TOWN OF DILLON PLANNING AND ZONING COMMISSION

REGULAR MEETING WEDNESDAY, MAY 6, 2020 5:30 p.m. VIRTUAL MEETING VIA MICROSOFT TEAMS CONFERENCE ID: 750 921 592#

CONSIDERATION OF RESOLUTION PZ 05-20, SERIES OF 2020 (PUBLIC HEARING)

A RESOLUTION RECOMMENDING THE APPROVAL OF A MAJOR PUD AMENDMENT FOR THE DILLON URGENT CARE & RESIDENCES PUD DEVELOPMENT PLAN LOCATED AT 956 W. ANEMONE TRAIL.

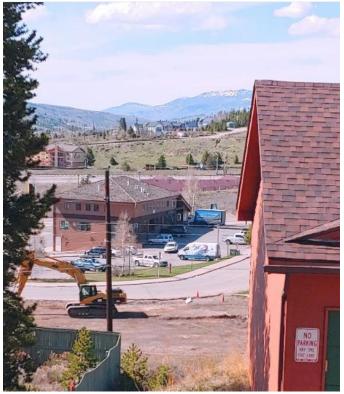
We do not feel items 2, 3 and 4 have been met. The proposed residence building spans 231 feet across nearly the entire length of the rear lot line. This is a very large rectangular building relative to the surrounding residences, which have been built mostly as smaller duplex to fourplex buildings. The rear of the proposed residential building is not interesting to look at, as it's flat with little architectural creativity, but it will become a large part of the view for Eagle View Estates and the surrounding neighbors. Allowing additional height above the current zoning allowance will only increase this impact and will have significant visual effect on our townhomes and adjacent residences.

It will also create a loss of view and will influence the vistas. The application includes a Site Section (Sheet A301) of the Eagle View Townhomes suggesting the views taken from the 3^{rd} floor. However, the townhomes have north and northwest facing decks on the 2^{nd} floor where the living, dining and kitchens are located and from where the views are typically enjoyed. From this level we can see the mountains and

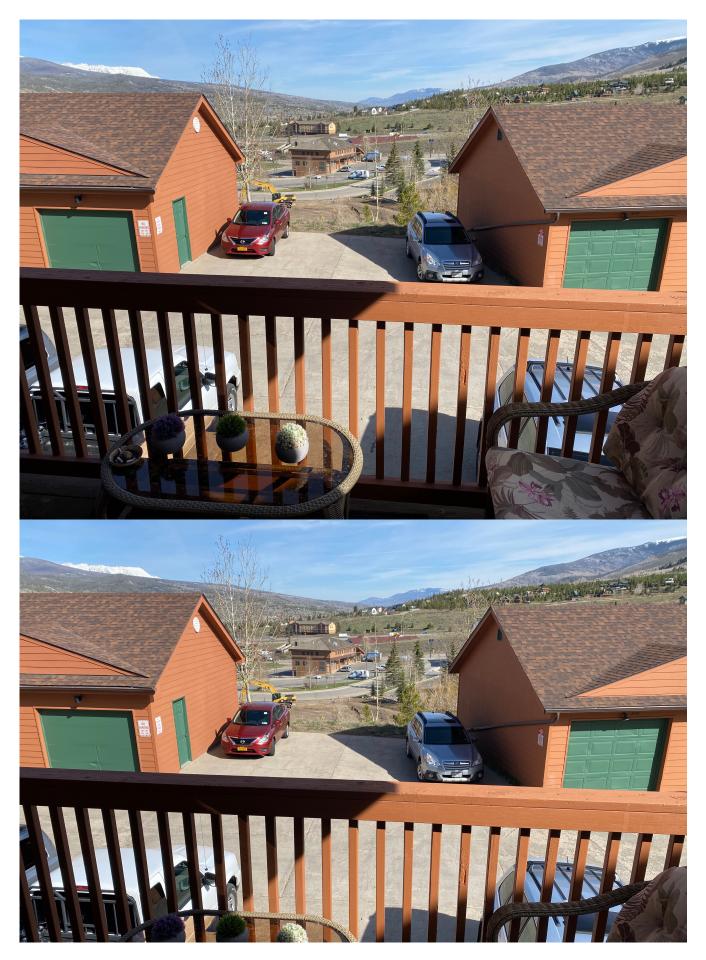
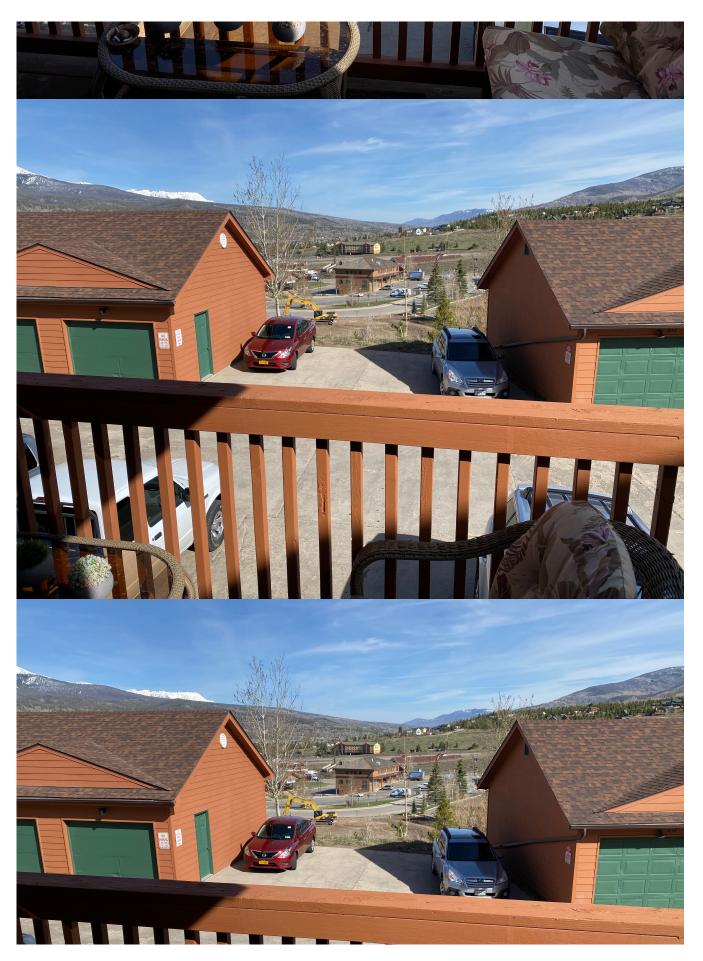
I would like to concur with the attached letter as expressed by our neighbors. We also oppose to the additional height as this would obstruct from current views specifically Unit 720A. We are lucky to have an end unit and our deck also happens to be in between garages so I would say we have one of the best views of the valley and mountains of the Eagle View Estates, as pictured below:
